Product Change Notice (PCN)

PCN Number: **PCN-0456188R-01**

Product(s) Affected: **PJ-030DH-SMT-TR**

PREVIOUS SAME SKY DETAIL / IMAGE	NEW SAME SKY DETAIL / IMAGE

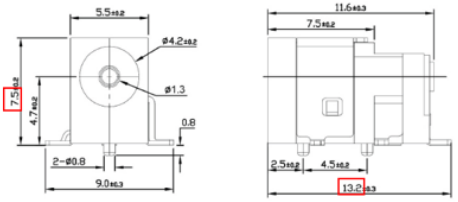
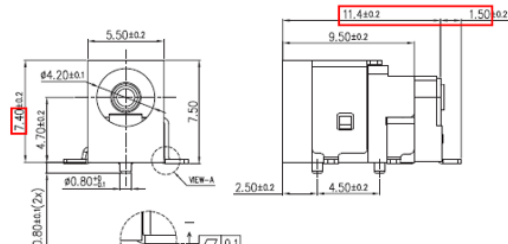
Description of Change: *New Factory Location. Product re-engineered for improved manufacturability and production yield. See image below for reference and check the Same Sky website for updated drawing after 10/20/2024. Cosmetic differences may be visible but will not affect the form fit and function of the product.*

PREVIOUS SAME SKY DETAIL / IMAGE			NEW SAME SKY DETAIL / IMAGE		
DESCRIPTION	MATERIAL	PLATING/COLOR	DESCRIPTION	MATERIAL	PLATING/COLOR
center pin	brass	tin	center pin	copper	nickel
terminal 1	brass t=0.3	silver	terminal 1	brass	silver over nickel
terminal 2	phosphorus bronze t=0.3	silver	terminal 2	copper alloy	silver over nickel
terminal 3	brass t=0.4	silver	terminal 3	brass	silver over nickel
shield	stainless steel	nickel	shield	cold rolled steel	nickel
housing	PPA [UL94V-0]	black	housing	PA10T [UL94V-0]	black

<p>MATING PLUG Jack Insertion Depth: 6.5mm</p>	<p>MATING PLUG Jack Insertion Depth: 6.6mm</p>
--	--
